# METROPOLITAN GOVERNMENT OF NASHVILLE AND DAVIDSON COUNTY

## STAFF RECOMMENDATION 1414 Eastland Avenue July 15, 2015

**Application:** Demolition—outbuilding; New construction—detached accessory dwelling unit; Setback determination  
**District:** Lockeland Springs-East End Neighborhood Conservation Zoning Overlay  
**Council District:** 06  
**Map and Parcel Number:** 08305038900  
**Applicant:** Jamie Day, B & B Construction  
**Project Lead:** Melissa Baldock, melissa.baldock@nashville.gov

<p><b>Description of Project:</b> Application is to demolish an existing outbuilding and construct a detached accessory dwelling unit (DADU) at the rear of the lot. The structure requires a rear setback determination.</p> <p><b>Recommendation Summary:</b> Staff recommends approval of the demolition of the existing outbuilding, the construction of a new detached accessory dwelling unit, and the setback determination with the following conditions:</p> <ol style="list-style-type: none"> <li>1. Staff approve the final details, dimensions and materials of windows and doors prior to purchase and installation;</li> <li>2. The siding have a maximum reveal of five inches (5"); and</li> <li>3. Staff

Figure 2 (left) shows the garage that is to be demolished and Figure 3 (right) is the 1957 Sanborn map that does not show the existing garage.

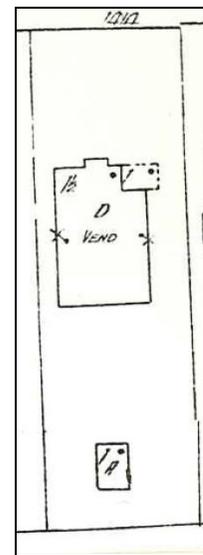
**Demolition:** The construction of the new DADU requires the demolition of an existing outbuilding at the rear of the property (Figure 2). The date of construction of the existing outbuilding is not known, but the structure does not appear on the 1957 Sanborn map (Figure 3). The structure's architecture and details do not contribute to the historic character of the site or to the larger district. Staff therefore finds that its demolition meets Section IV.B.2. for appropriate demolition and does not meet Section IV.B.1. for inappropriate demolition.

01 SITE PLAN

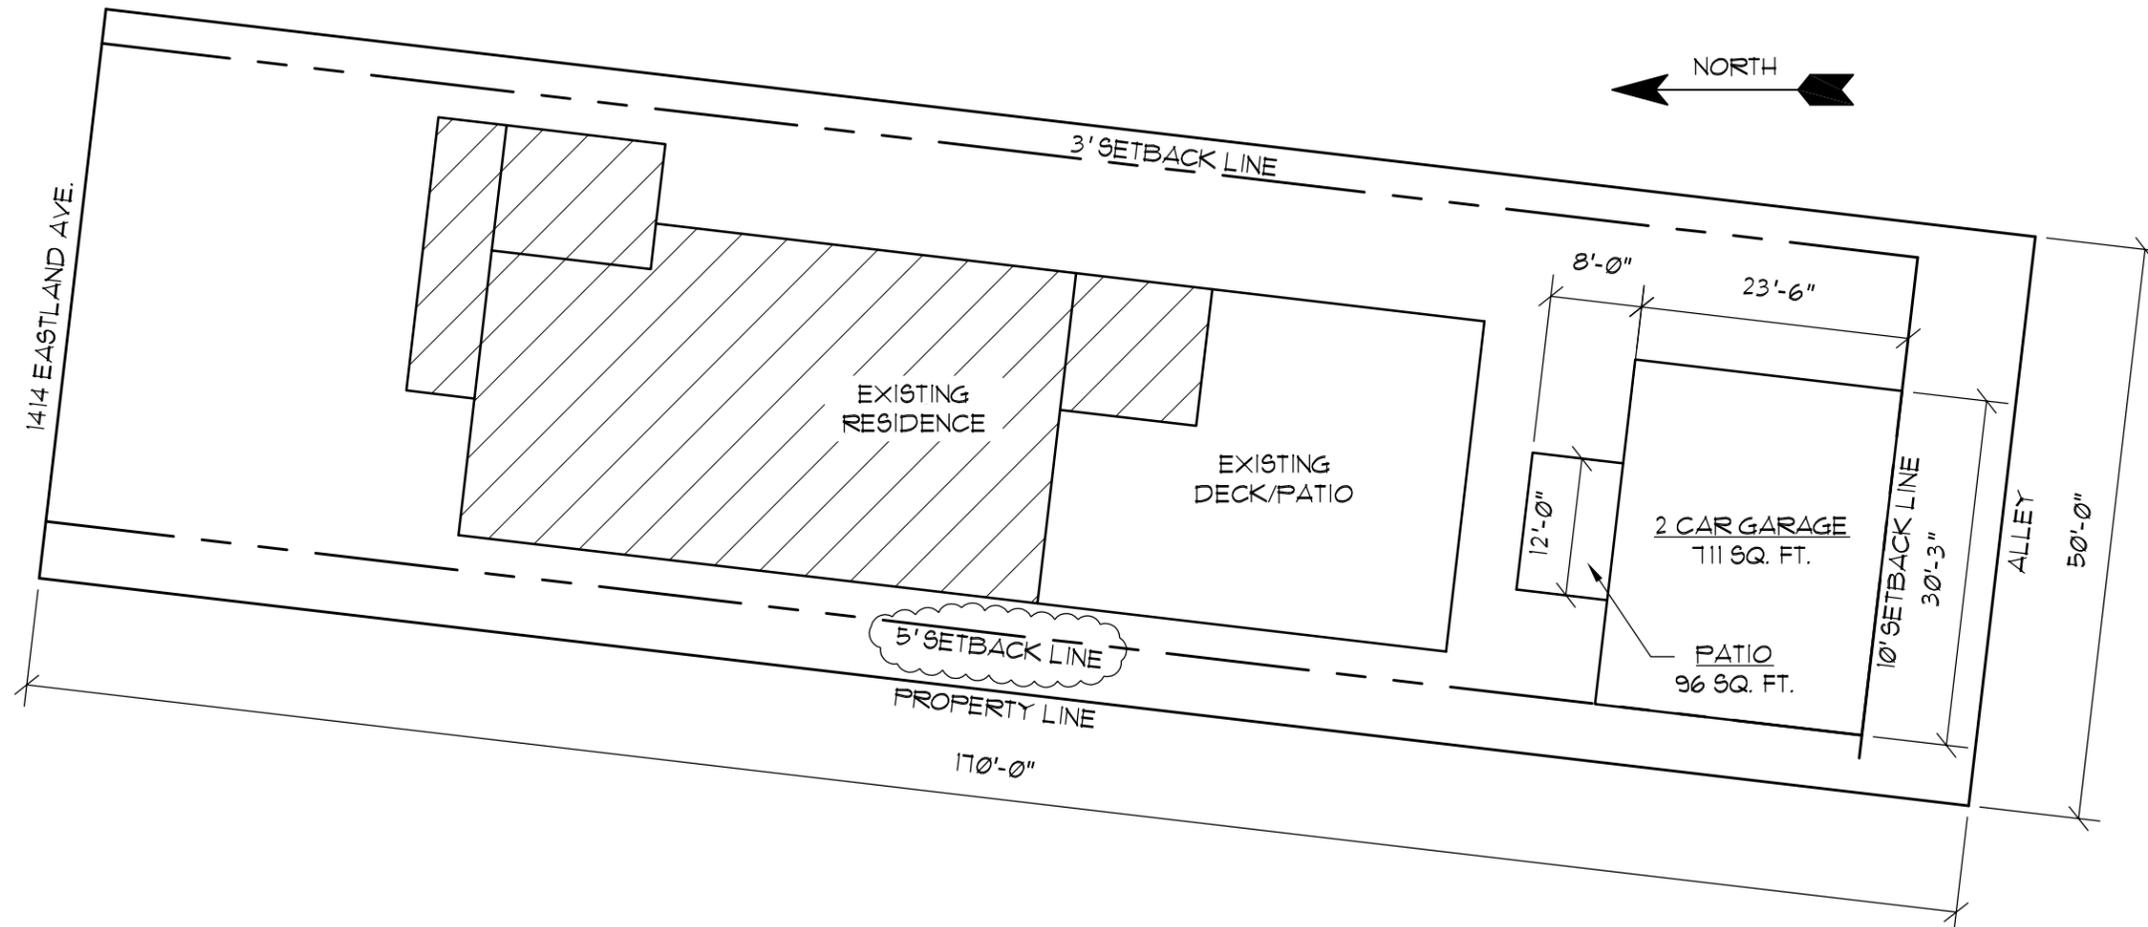
The new outbuilding does require a reduction to the rear setback. When an outbuilding has a footprint greater than seven hundred square feet (700 sq. ft.), base zoning requires that the structure be located twenty feet (20’) from the rear property line and five feet (5’) from the side property lines. In this instance, the structure is located at least five feet (5’) from the side property lines, but it is located ten feet (10’) from the rear property line. Staff finds that the proposed rear setback is appropriate because a ten foot (10’) setback is the standard rear setback for structures that are seven hundred square feet (700 sq. ft.) or less. Also, historically, outbuildings were located at the rear of the property, close to the rear property line. A ten foot (10’) rear setback is more historically appropriate than a twenty foot (20’) rear setback. In addition, the ten foot (10’) rear setback allows for more space between the primary structure and the DADU. Staff recommends approval of the setback determination.

MINIMUM	PROPOSED
Space between principle building and DADU/Garage	20'	37'
Rear setback	3'	10'
L side setback**	3'	14''
R side setback**	3'	5'
How is the building accessed?	From the alley or existing curb cut	Rear/Alley

01 FIRST FLOOR PLAN  
711 SQ. FT.

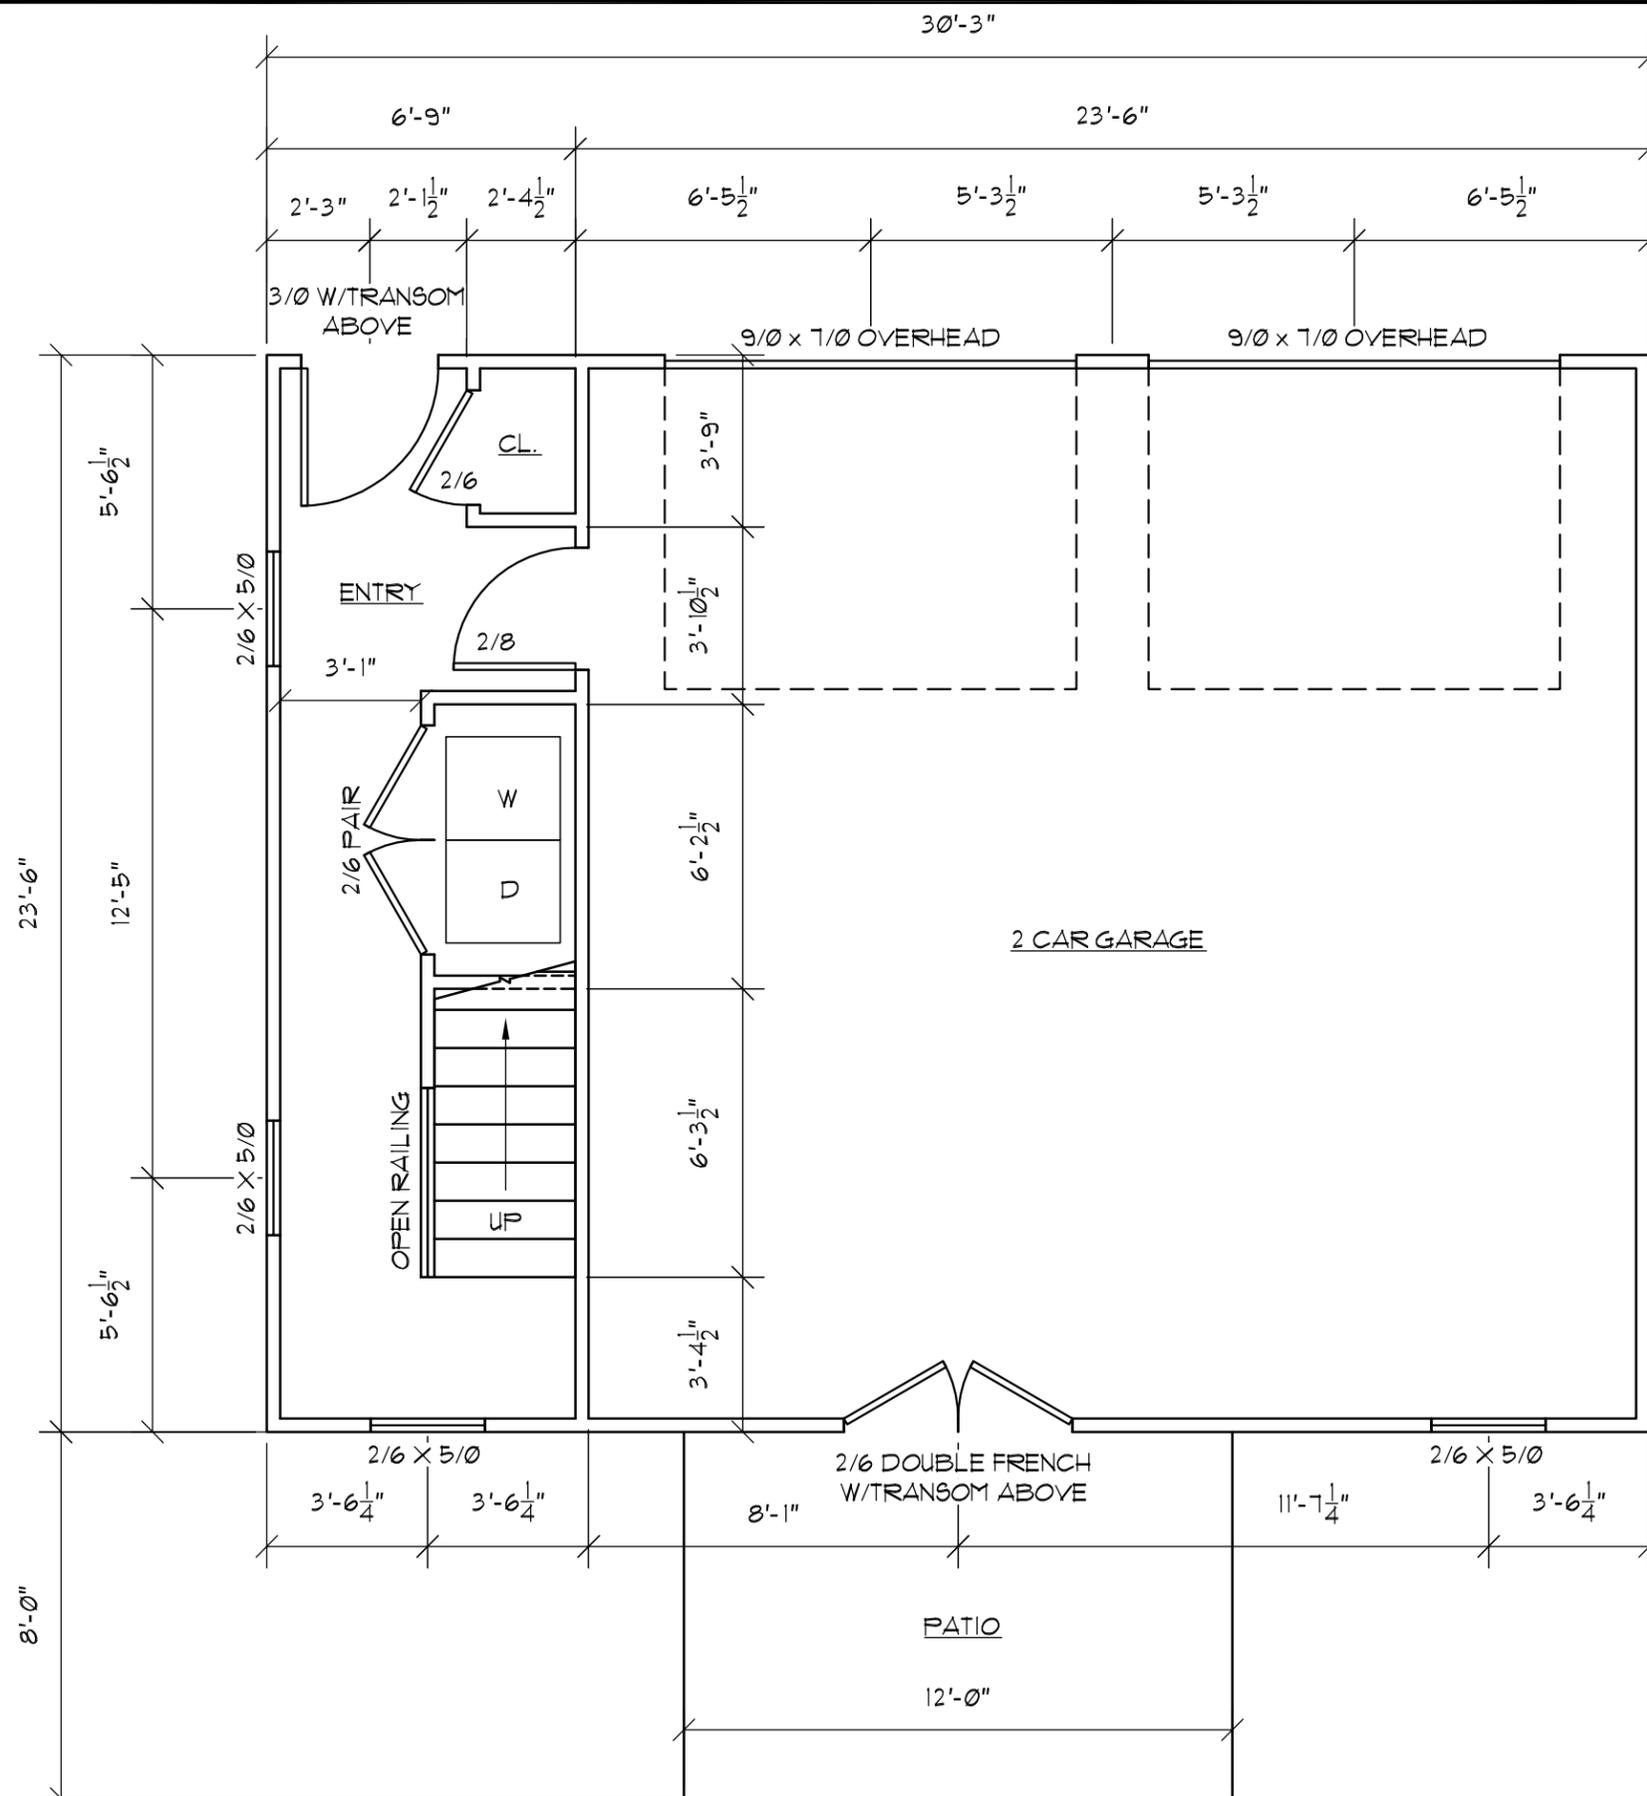
The proposed DADU will be one-and-a-half stories and with a footprint of seven hundred and eleven square feet (711 sq. ft.). It will be subordinate to the historic structure. It will be approximately twenty-two feet, five inches (22’5”) tall, which is lower than the height of the historic house. Its eave height will be less than ten feet (10’). The materials for the DADU have all been approved by the Commission in the past, and include cement fiberboard siding, wood and cement fiberboard trim, asphalt shingles to match those on the historic house, and a cement slab for the foundation. Staff recommends that the siding have a maximum reveal of five inches (5”). The materials for the windows and doors were not indicated, and staff recommends approval of the window and door selections prior to purchase and installation.

1. Staff approve the final details, dimensions and materials of windows and doors prior to purchase and installation;
2. The siding have a maximum reveal of five inches (5”); and
3. Staff receive a copy of the restrictive covenant for the detached accessory dwelling unit.
